SERVICE BULLETIN REVISION NOTICE

NON-MODIFICATION SERVICE BULLETIN — ENGINE — TURBINE EXHAUST CASE (TEC) —
EDDY CURRENT INSPECTION (ECI)

Turbojet Engine Service Bulletin No. 72-0694 Revision No. 2 dated July 2, 2018.

Reason for the Revision

RIGHT ENGINE MOUNT LUG INSPECTION AREA
FIGURE 8

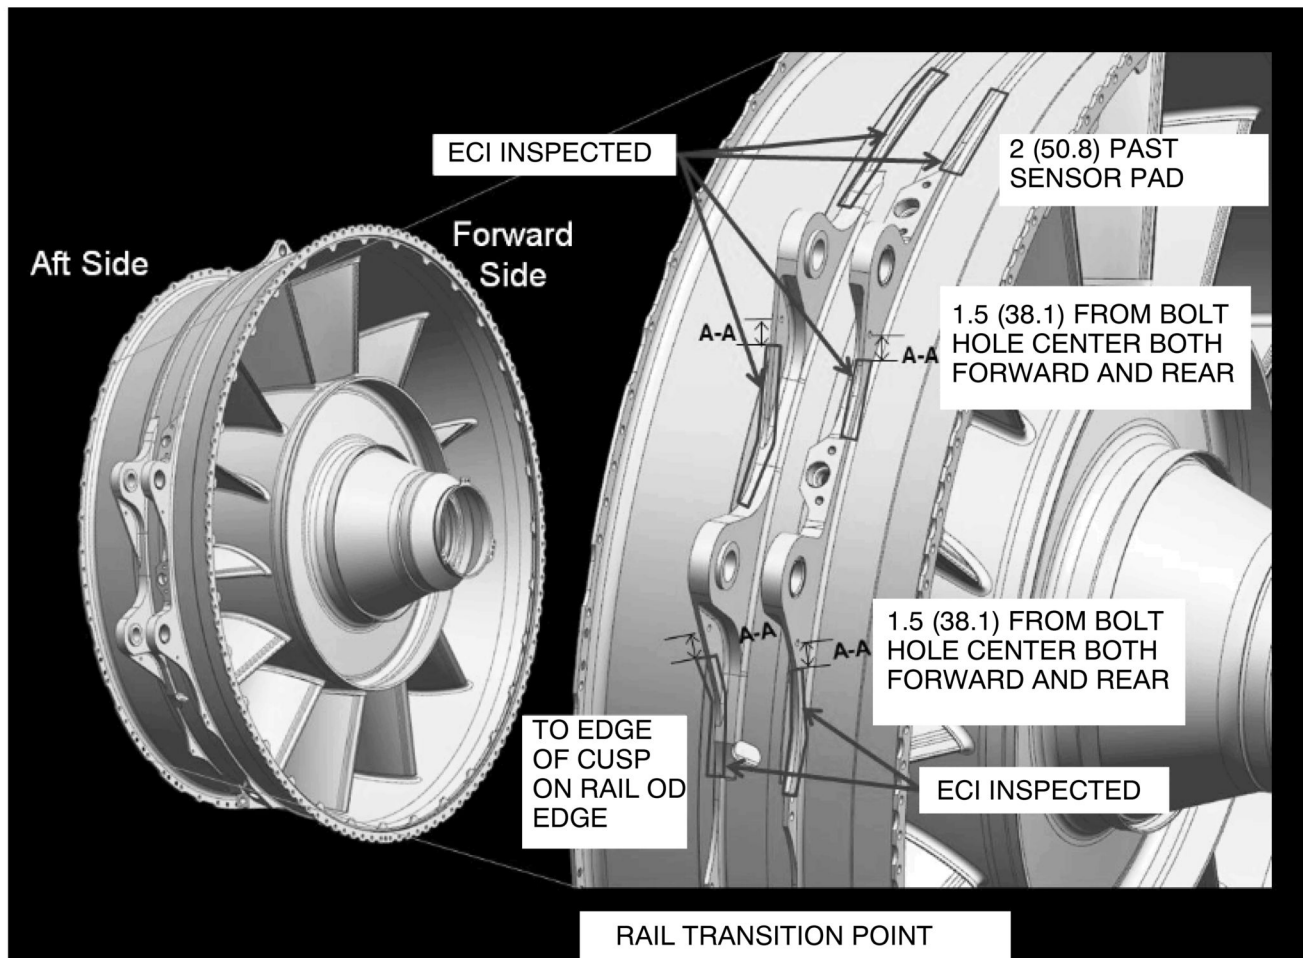
To revise Figure 8, 9 and 10.

- E. Figure 8 shows the inspection zone for the right hand side of the turbine exhaust case when viewed from the AFT looking FWD (Position 1 Mount). The inspection zone begins 2 ± 0.2 inches (50.8 ± 5.0 mm) past the sensor pad and ends at the cusp of

LEFT ENGINE MOUNT LUG INSPECTION AREA
FIGURE 9

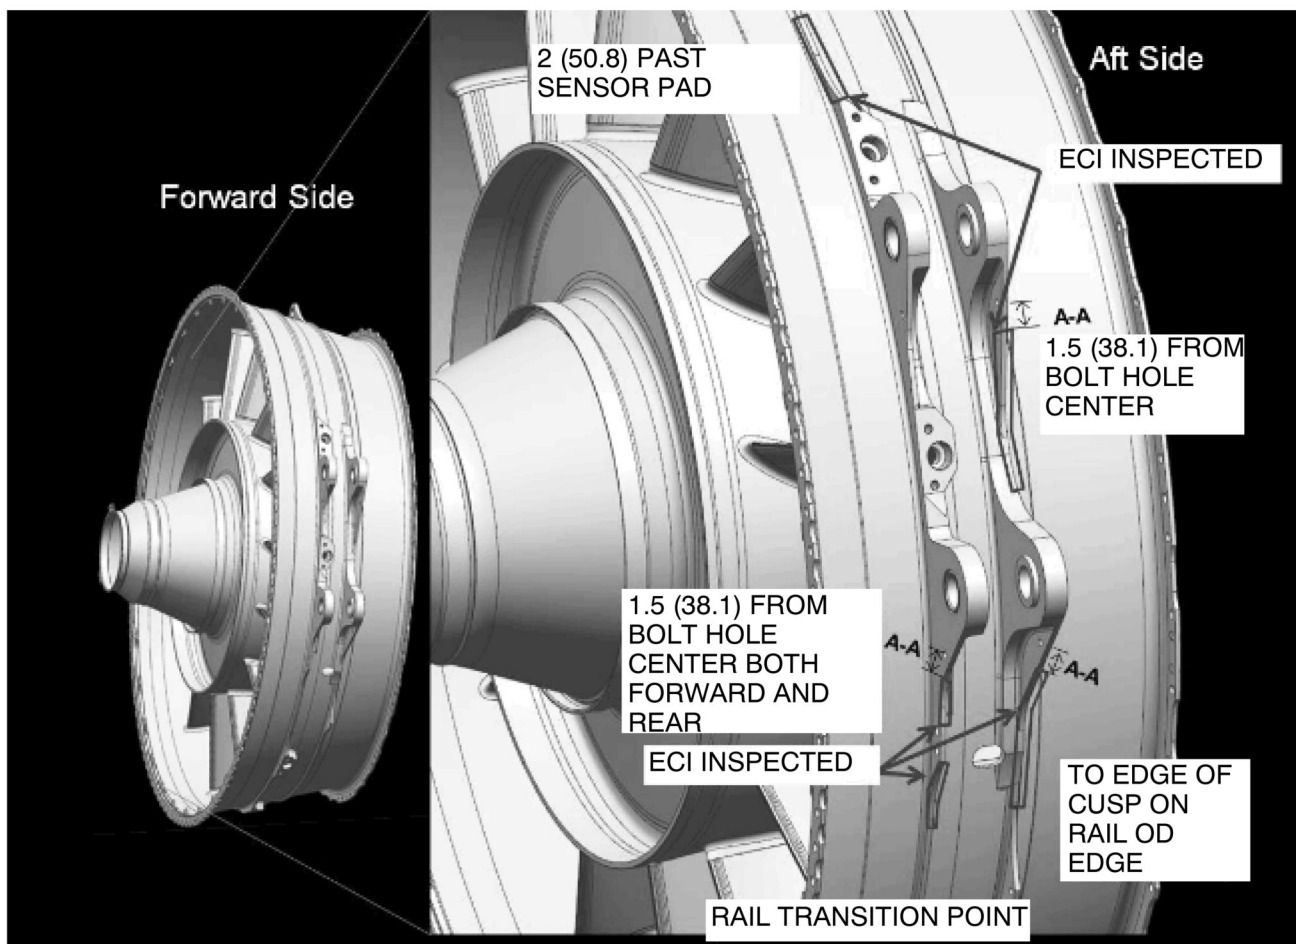
- F. Figure 9 shows the inspection zone for the left hand side of the turbine exhaust case when viewed from the AFT looking FWD (Position 2 Mount). The inspection zone begins 2 ± 0.2 inches (50.8 ± 5.0 mm) past the sensor pad and ends at the cusp of the rail transition point. Note the 1.5 inches (38.1 mm) non-inspect areas around the four bolt hole locations are indicated as View "A-A" and discussed further below.

EXPANDED VIEW OF THE INSPECTION ZONE
FIGURE 10

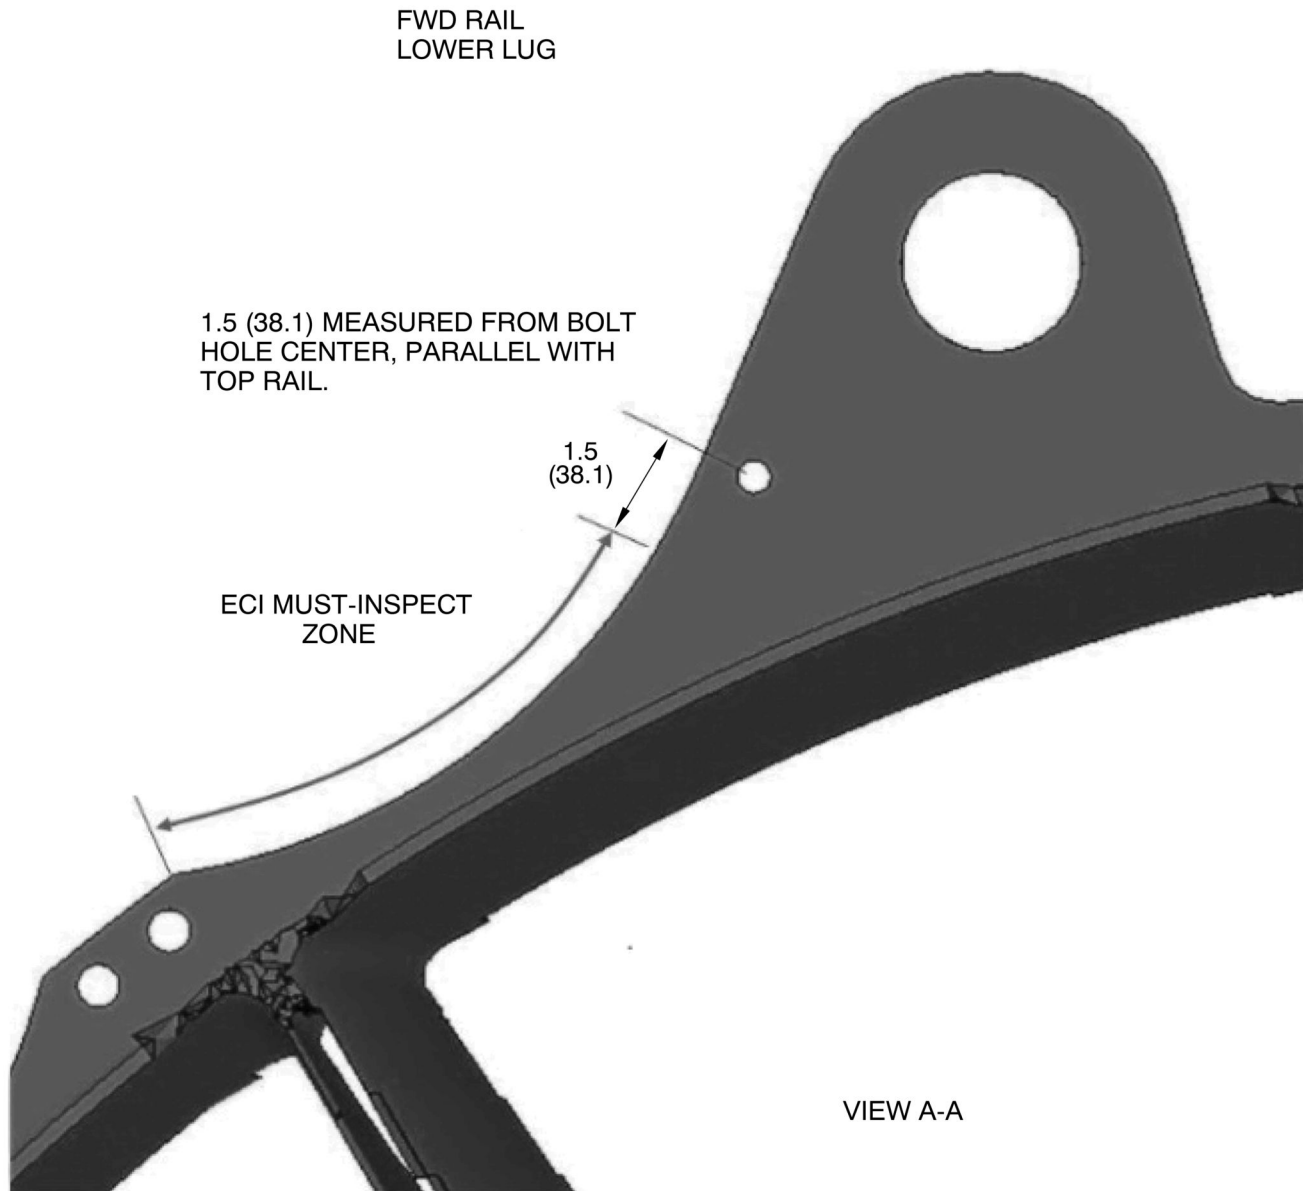
- G. A non-inspect area has been defined approximately 1.5 ± 0.1 inches (38.1 ± 2.5 mm) around the four bolt holes noted as View A-A in Figures 8 and 9. There are four holes per side. Figure 10 shows the expanded View A-A of the non-inspect area around one of the four bolt holes.
